ADDENDUM NO. 3

1904 / KVCC WHITNEY WING RENOVATIONS

Lewis + Malm Architecture

30JAN2020

KVCC WHITNEY WING RENOVATION
 FAIRFIELD, MAINE
 HVAC PIPING & DUCTWORK PLANS

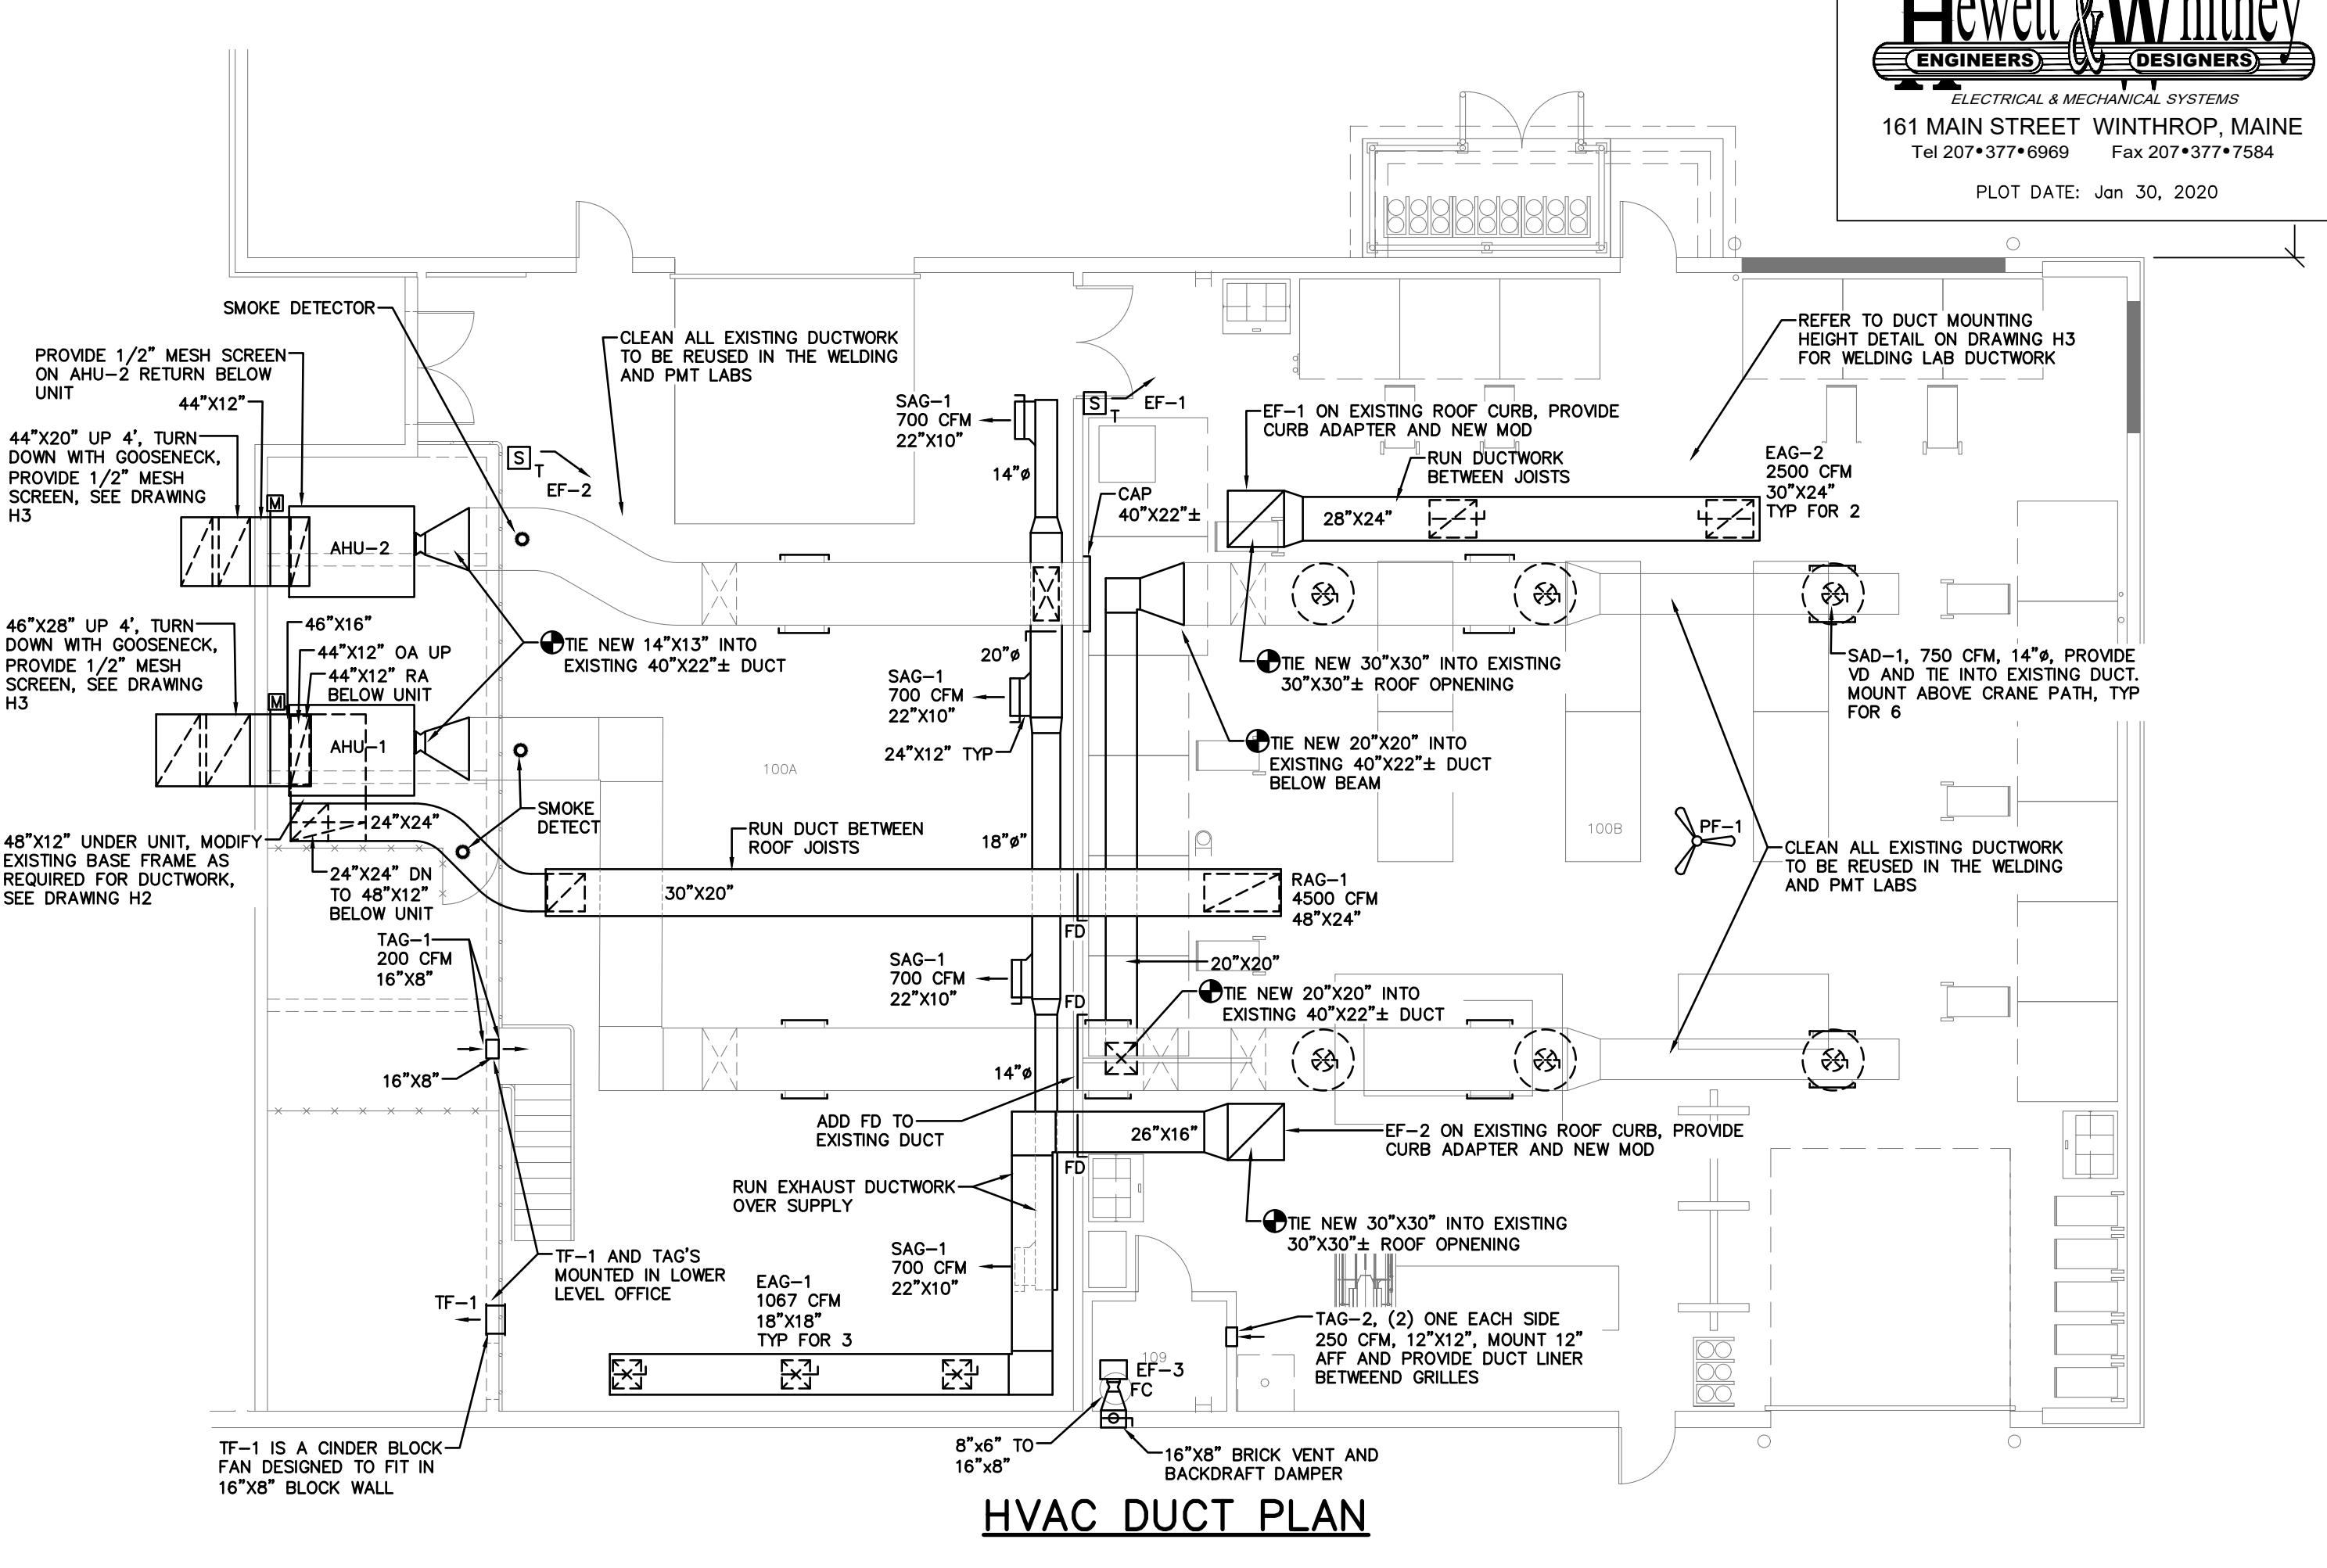
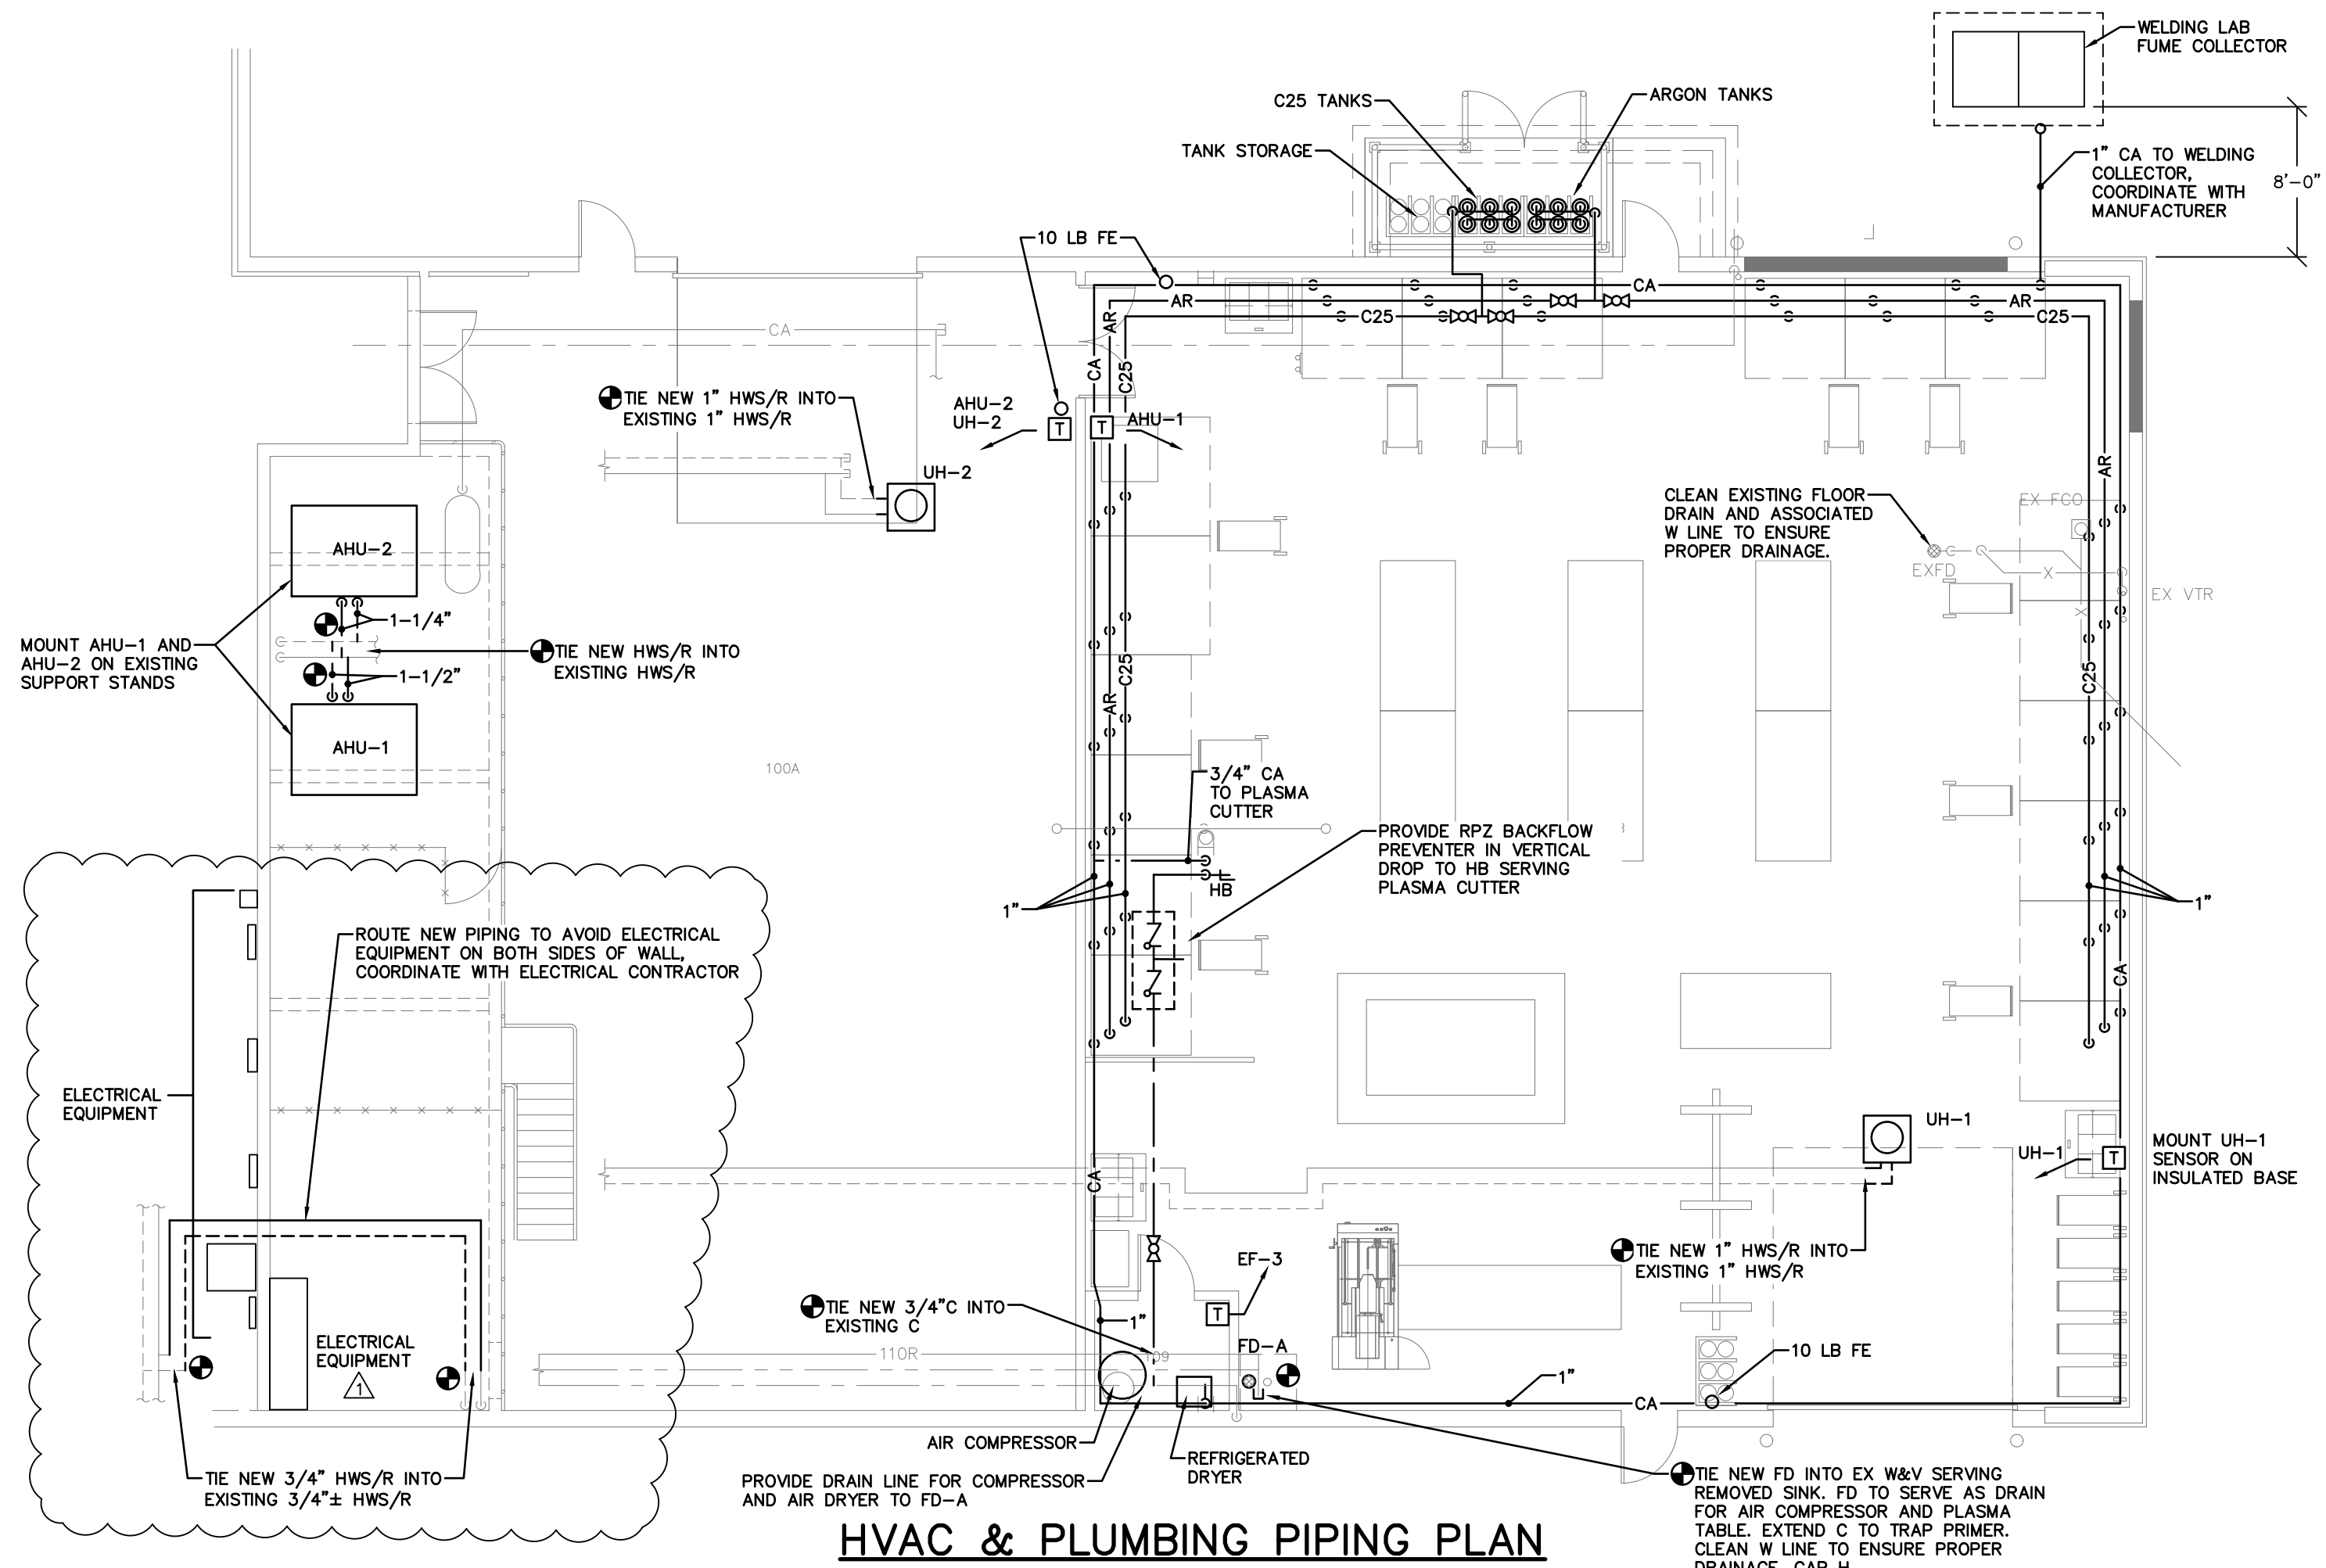
H1 ADD the drawing attached to this Addendum in its entirety (shows existing HWS/R

piping be rerouted around electrical equipment on the mezzanine).

WELDING BOOTH ELECTRICAL LAYOUT - 5' X 5'

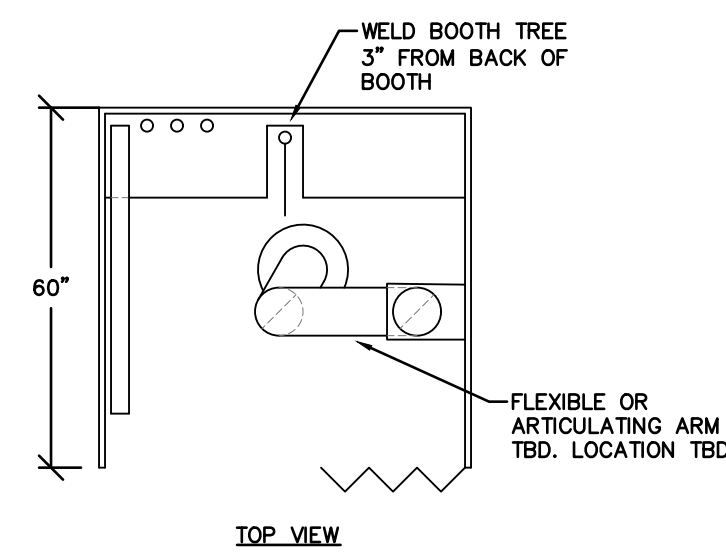
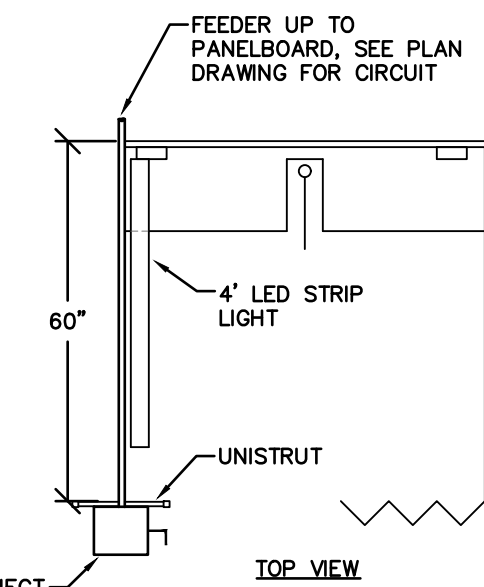
QUESTION 6) Please clarify responsibility for furnishing and installing the welding booth unistrut frames depicted on the "welding booth electrical layout - 5' x 5' detail", and the "unistrut wall layout detail", both details shown on electrical drawing E01. Is the intent for the EC to furnish, install and secure to wall and floor, the unistrut frame for the welding booth?

RESPONSE to Q6: It is the responsibility of the Electrical Contractor to provide the unistrut to mount electrical equipment such as Panels WL and WH2 and the disconnects and welding receptacles. The General Contractor shall provide the welding booth metal framing, walls and accessories, as specified and indicated.

COMPRESSED AIR BRANCH MAIN DETAIL

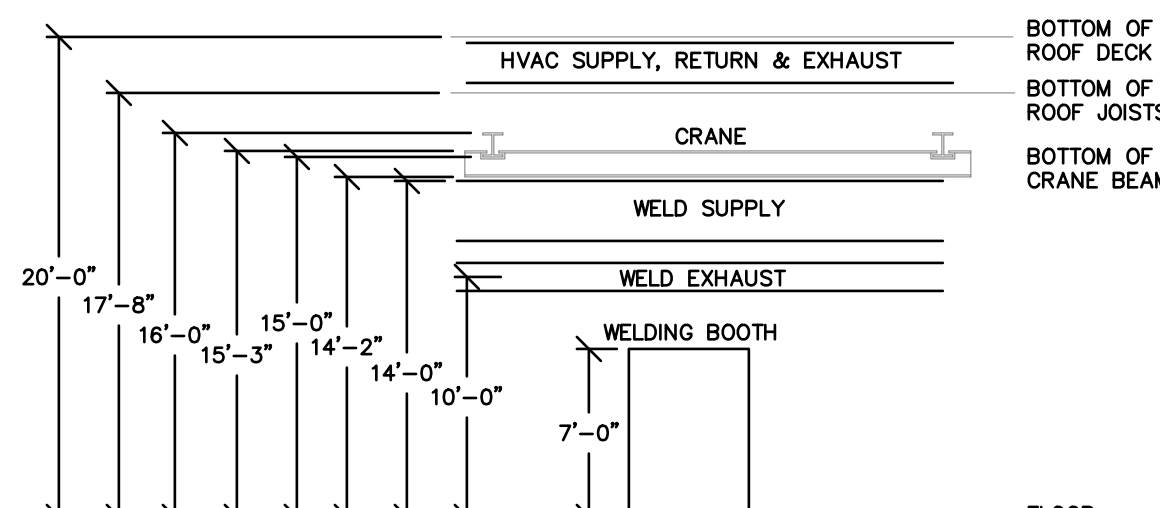
H3 ADD the drawing attached to this Addendum in its entirety (shows the strainer being removed from the compressed air piping detail and being replaced with a ½” pressure regulator).
